CABLE TRAY

PX3-2430

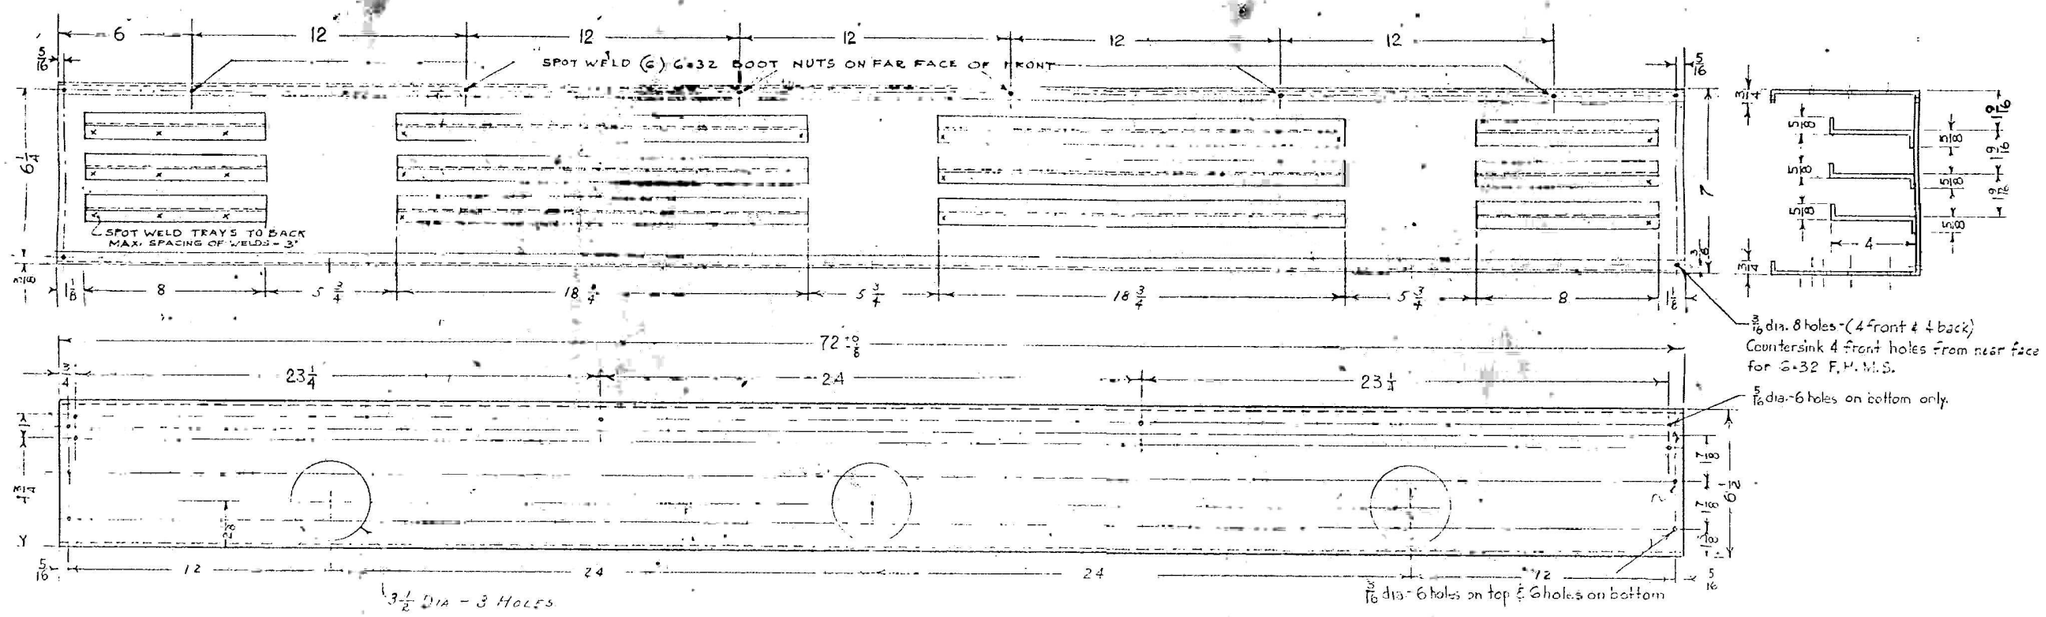
REVISIONS		
#16 GA. CHANGED TO #18 GA. SHEET STEEL	J. Lemmings 8/20/42	1
TRAYS REVISED - SPOTWELDED ANGLES NOW DIVIDED INTO 4 SECTIONS. RECTANGULAR CUT-OUTS ON BOTTOM REPLACED BY 3/8 D.A. HOLES.	J. Lemmings 5-4-45	2
